NOTICE OF DECISION

**URBAN GROWTH PRELIMINARY DECLARATION / CLASS 3 SITE PLAN
REVIEW / CLASS 2 ADJUSTMENT / CLASS 2 DRIVEWAY APPROACH PERMIT
/ TREE REGULATION VARIANCE CASE NO.: UGA-SPR-ADJ-DAP-TRV22-01**

SUMMARY: Development of a new industrial use building with associated site work.

LOCATION: 4400 Block of Turner Rd SE

PRELIMINARY SITE PLAN

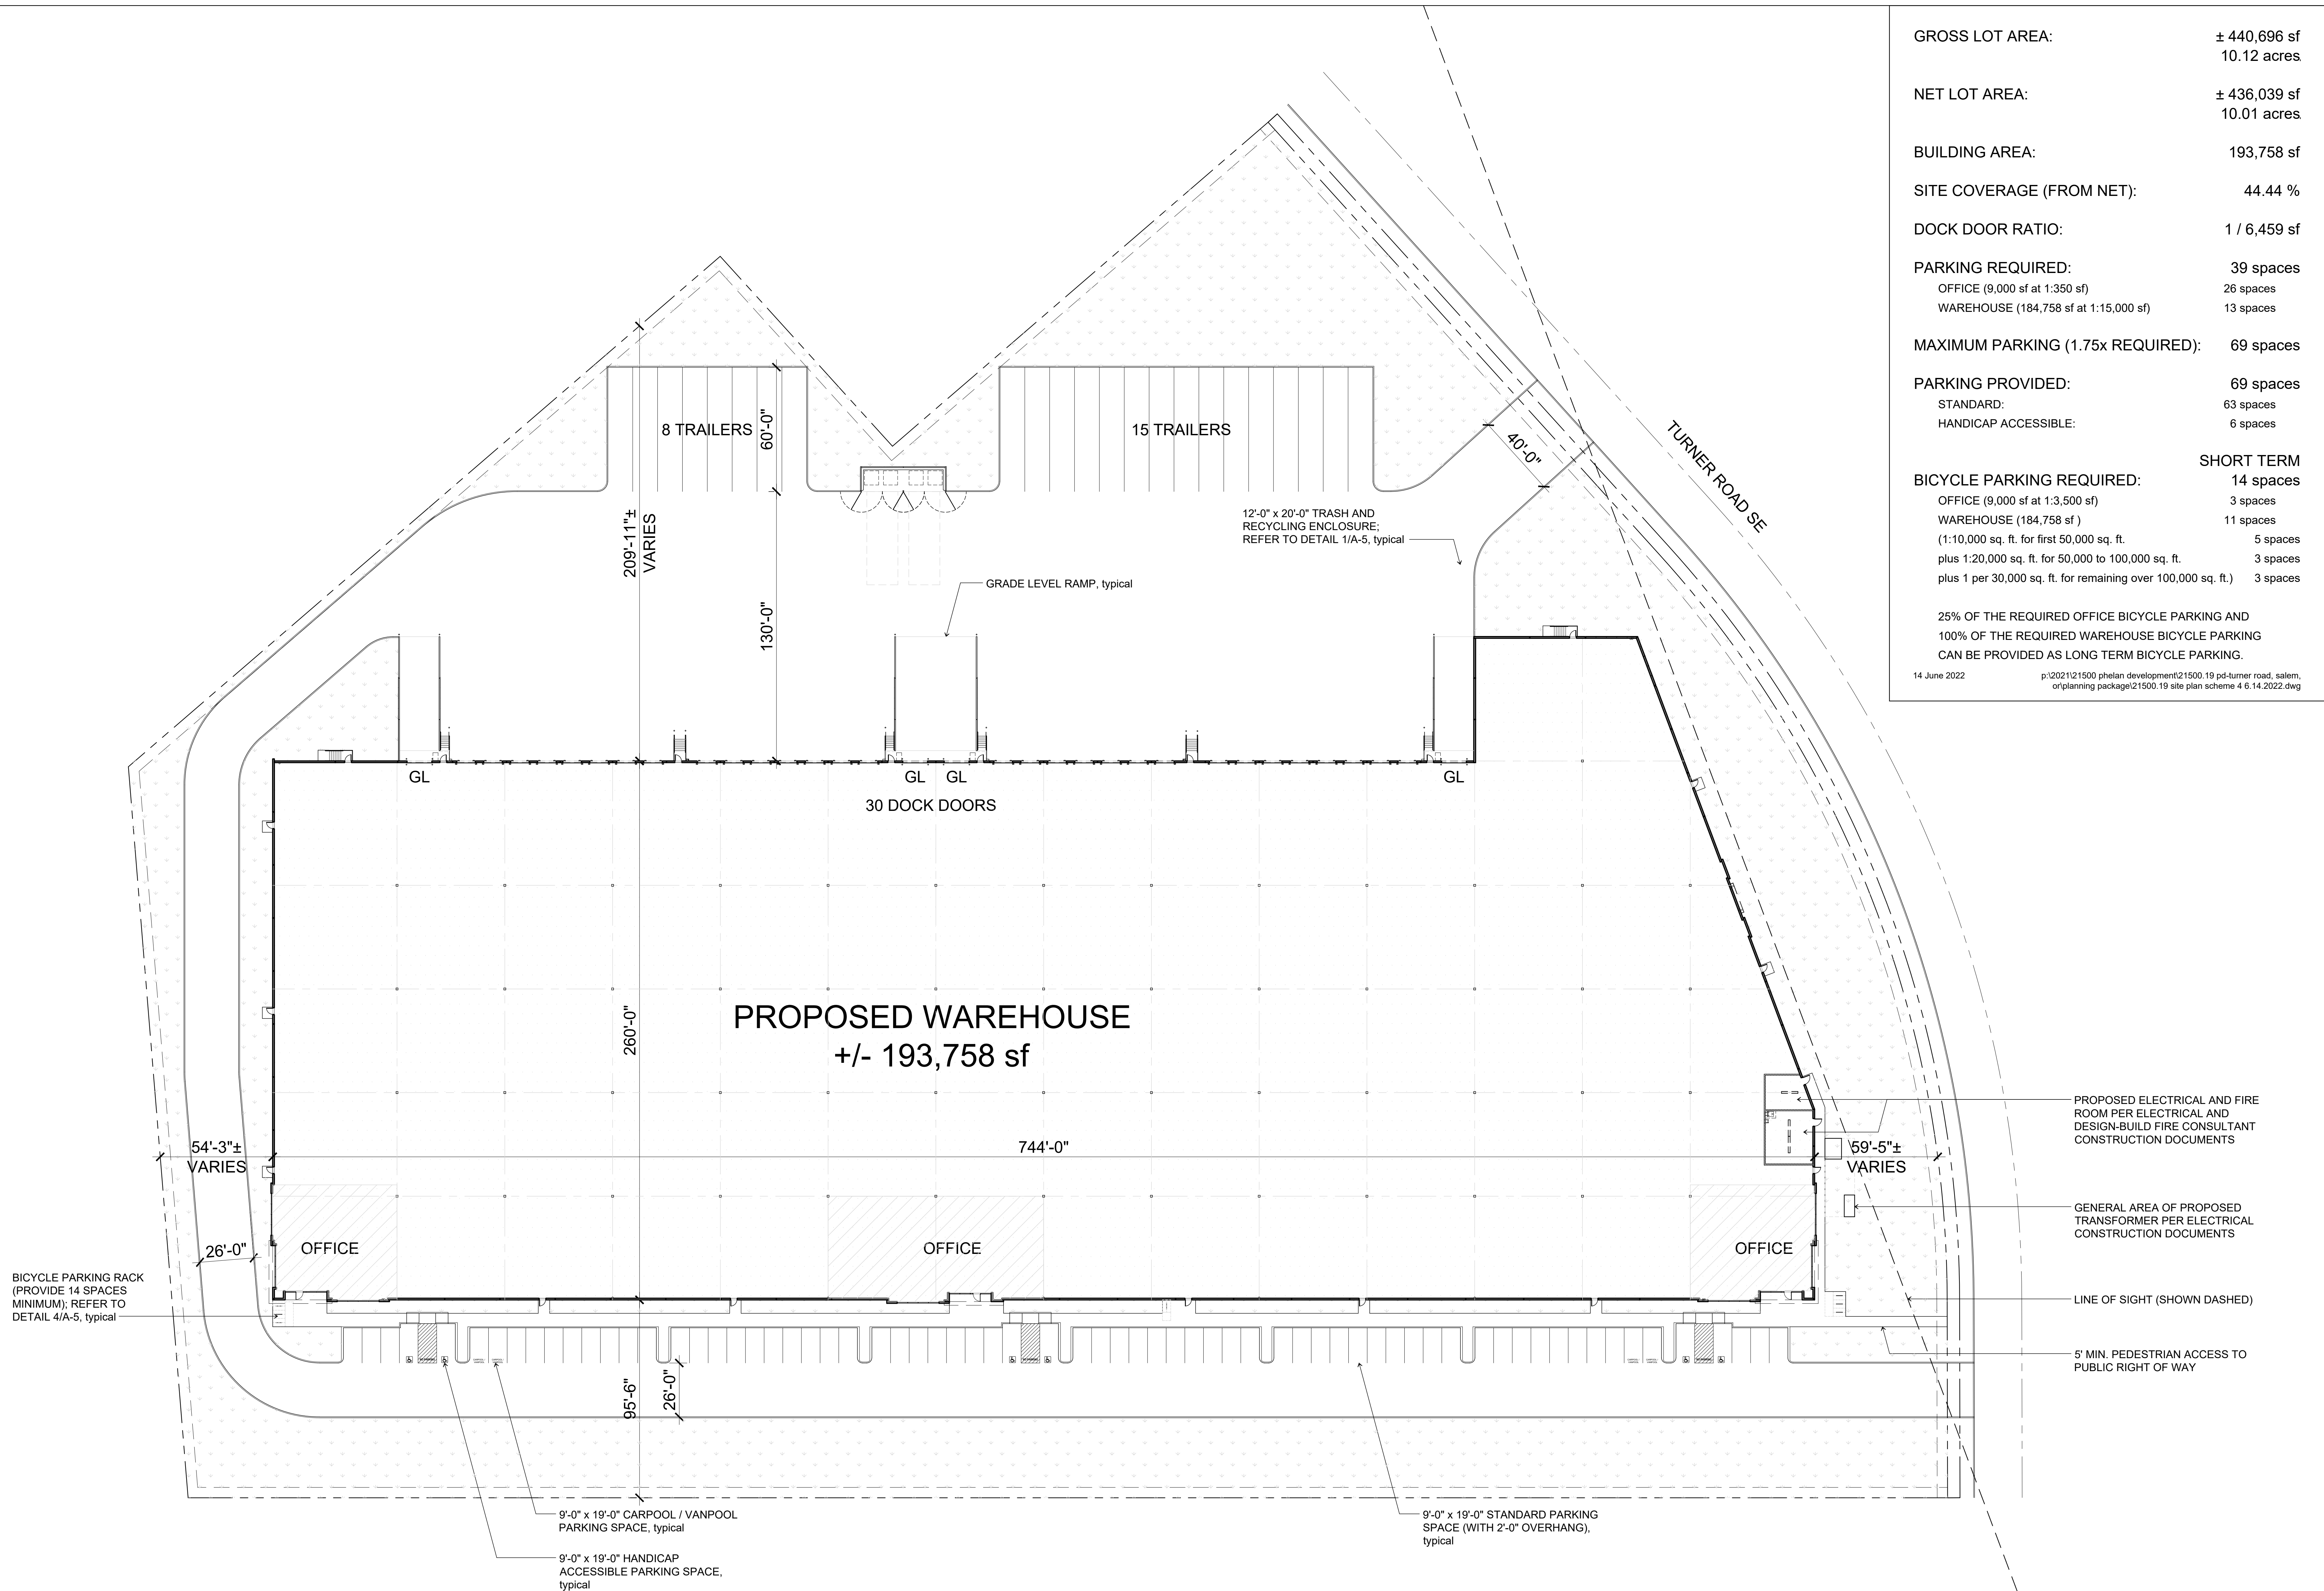
Condition 11: Two significant trees, a split trunk Oregon White Oak with the largest measurement of 28 inches dbh (Tree No. 12673) and a 30-inch dbh Oregon White Oak (Tree No. 12741), shall be retained and preserved on site, with the required protection measures provided for significant trees during construction (SRC 808.046). At the time of building permit review, the applicant shall provide updated landscaping indicating the critical root zone of these trees and all protection measures, and updated plans reducing the trailer parking area to ensure protection of these trees.

The proposed site plan indicates that 69 parking spaces will be provided on site, 4 carpool/vanpool parking spaces are indicated on the site plan, and no compact spaces are proposed. The applicant has proposed two more parking spaces than allowed by the maximum parking calculation ($38 \times 1.75 = 66.5$). As such, the following condition applies:

- Condition 3:** At the time of building permit, the applicant shall adjust the parking area to include only the 67 parking spaces allowed by the maximum parking requirement.

Condition 11: Two significant trees, a split trunk Oregon White Oak with the largest measurement of 28 inches dbh (Tree No. 12673) and a 30-inch dbh Oregon White Oak (Tree No. 12741), shall be retained and preserved on site, with the required protection measures provided for significant trees during construction (SRC 808.046). At the time of building permit review, the applicant shall provide updated landscaping indicating the critical root zone of these trees and all protection measures, and updated plans reducing the trailer parking area to ensure protection of these trees.

TREE INFORMATION

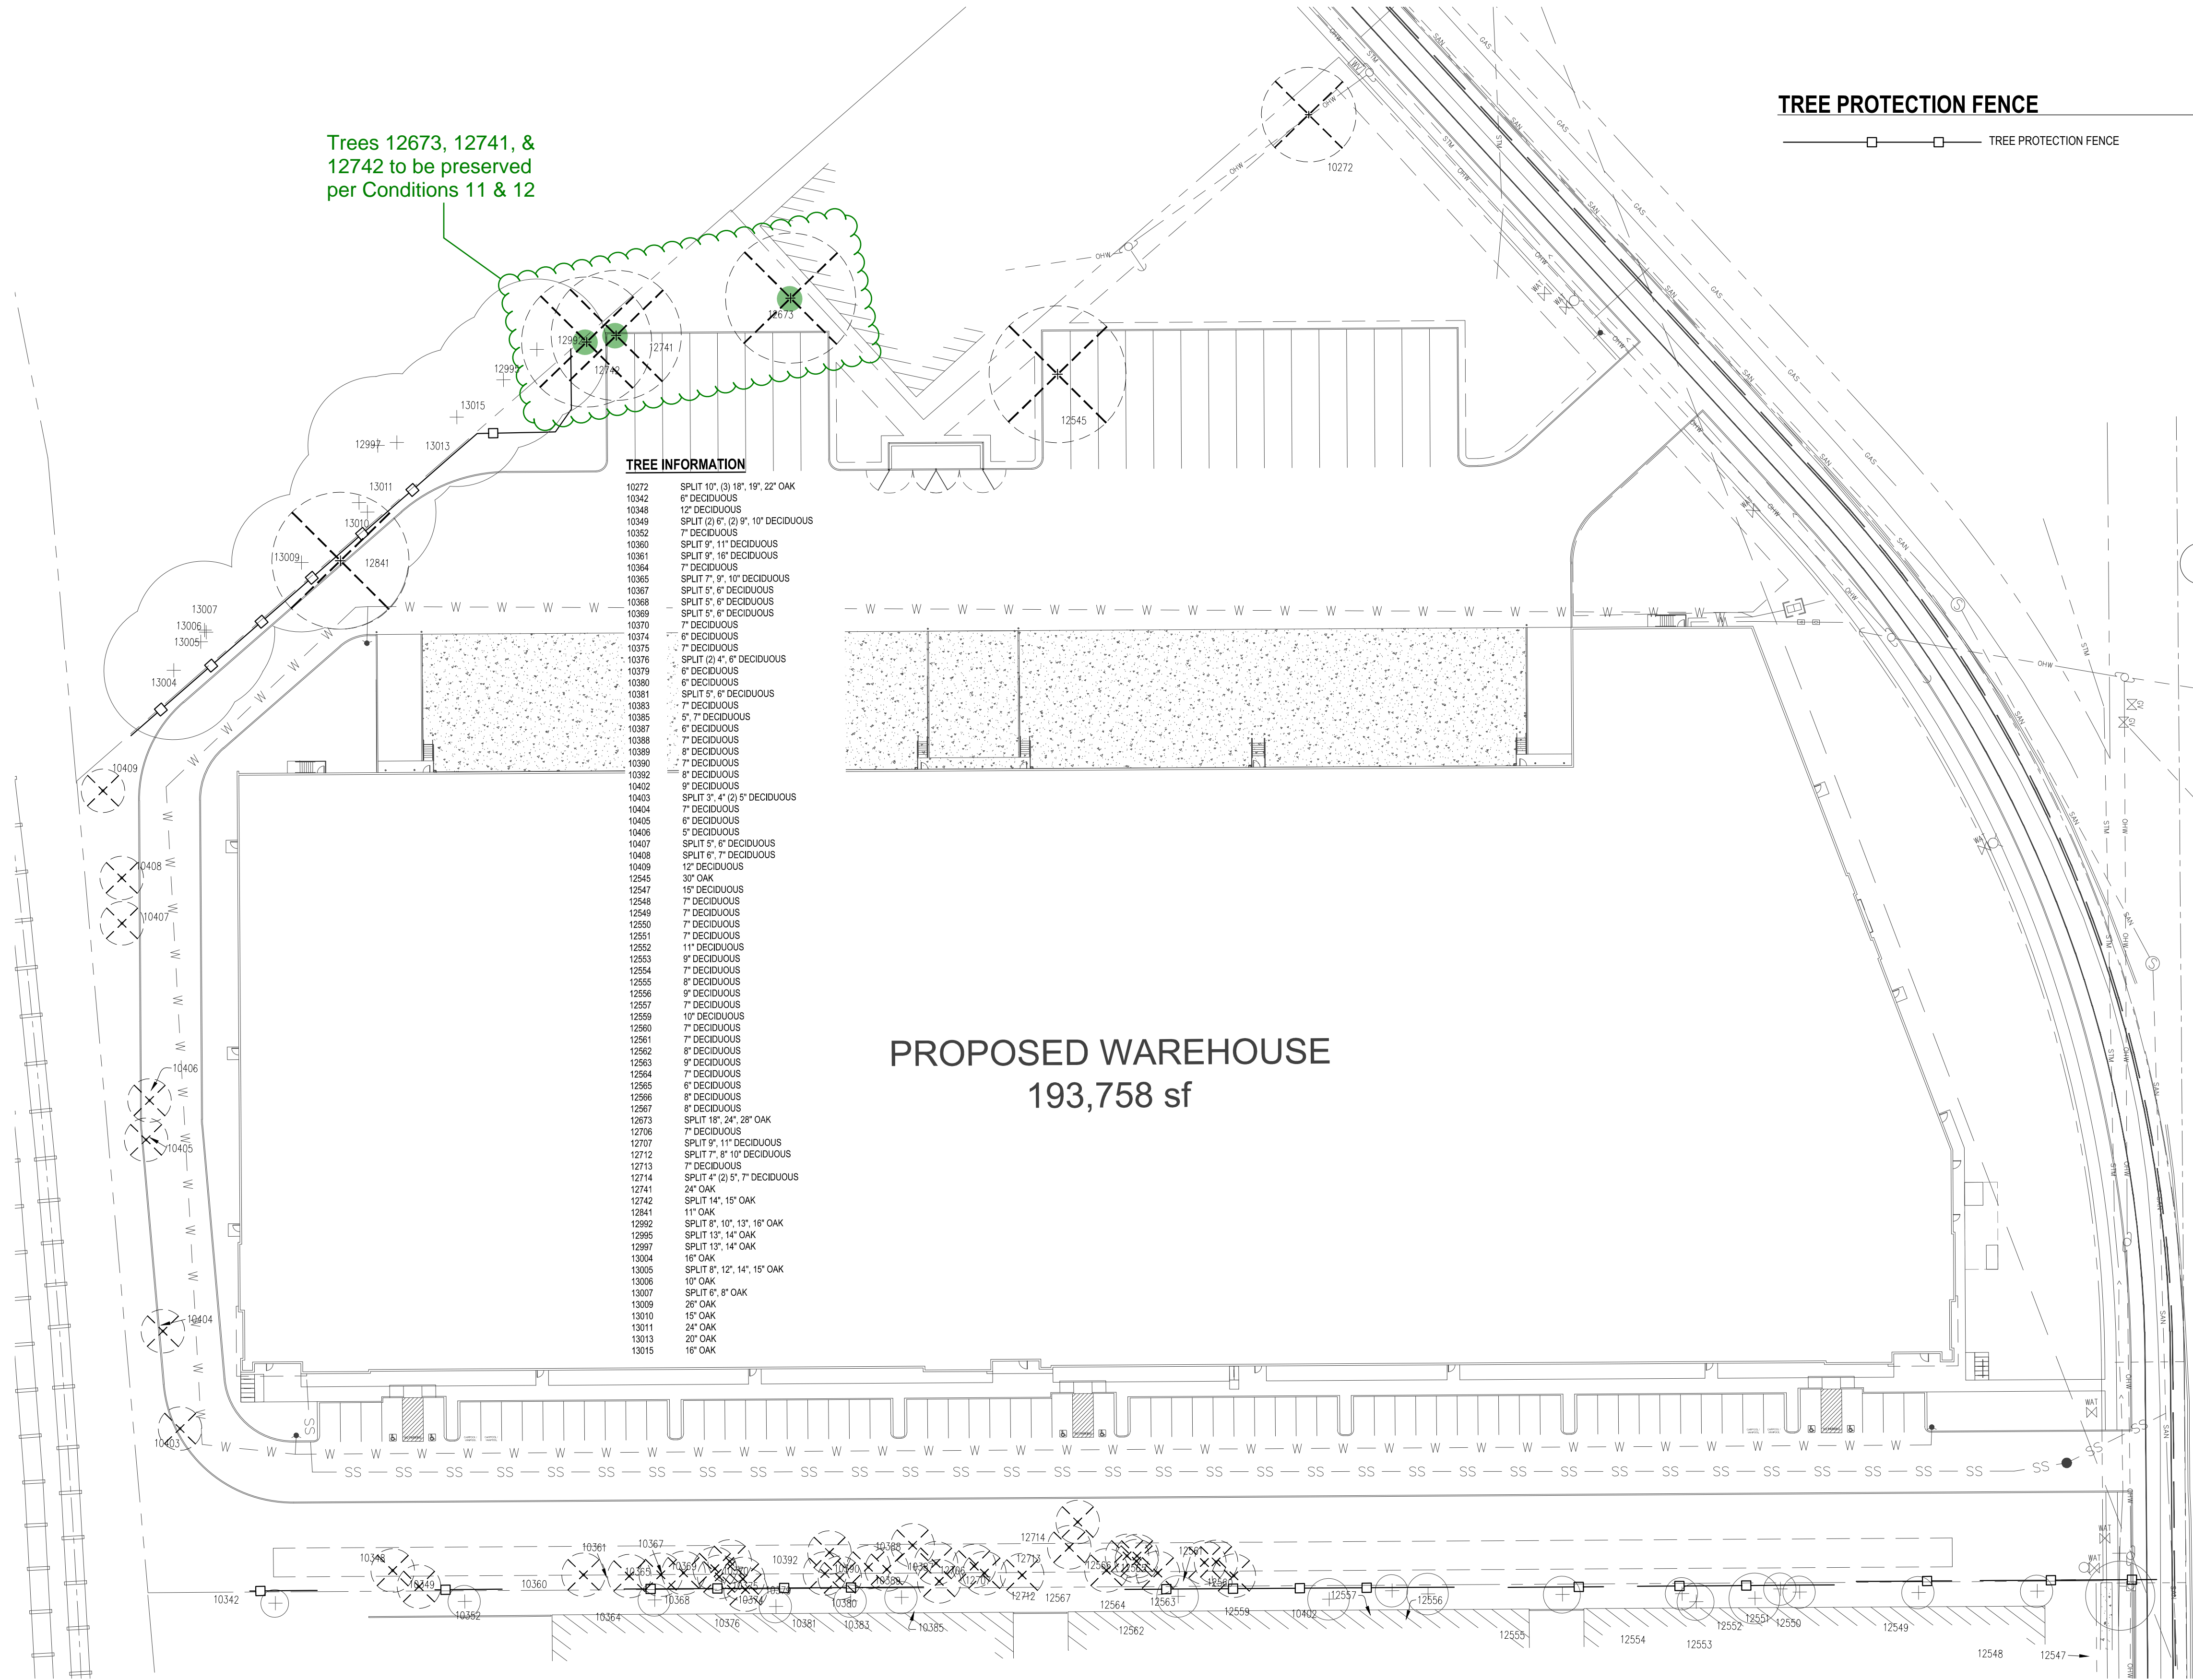
Finding: The applicant submitted a tree plan in conjunction with the proposal identifying a total of four significant trees (Oregon White Oak greater than 20 inches in diameter-at-breast height (dbh), or any other tree with a dbh of 30 inches or greater) on the property. In the written statement for the Tree Variance, the applicant requests to remove all four significant trees due to their locations severely limiting the development of the site. However, the applicant proposed minor changes to the site plan after the application was deemed complete and notice was sent, including a request to remove two additional trees under this Tree Variance to accommodate an expanded vehicle use area not required by code; the initial proposal requested removal of only two significant trees. As such, Staff finds that the two additional trees requested for removal do not meet the criteria for hardship, as the site is able to be developed without their removal, as evident with the initial proposal for the development. In addition, the location of the two trees in question, Tree No. 12673 and Tree No. 12741, would only limit the development of an expanded large-vehicle trailer parking or storage area, which is not considered required parking under the Salem Revised Code. The development is still able to provide a separate area of fifteen trailer parking spaces, and an additional eight spaces does not render the development unusable or create an unreasonable hardship. As such, the following condition applies:

The request to remove these two significant trees is directly related to the need to provide stormwater facilities on site. The trees are located within the proposed stormwater facility area and would interfere with providing the necessary infrastructure to meet standards. The preliminary stormwater design demonstrates the use of green stormwater infrastructure to the maximum extent feasible and demonstrates compliance with Stormwater PWDS Appendix 004-E(4) and SRC Chapter 71. There are no other options to provide the required stormwater facilities on site; retaining the trees creates an unreasonable hardship that can most effectively be relieved by approval of the variance.

Condition 12: Tree No. 12742, a split trunk Oregon White Oak with the largest measurement of 15-inch dbh, shall also be retained and preserved on site, with the required protection measures provided for significant trees during construction (SRC 808.046).
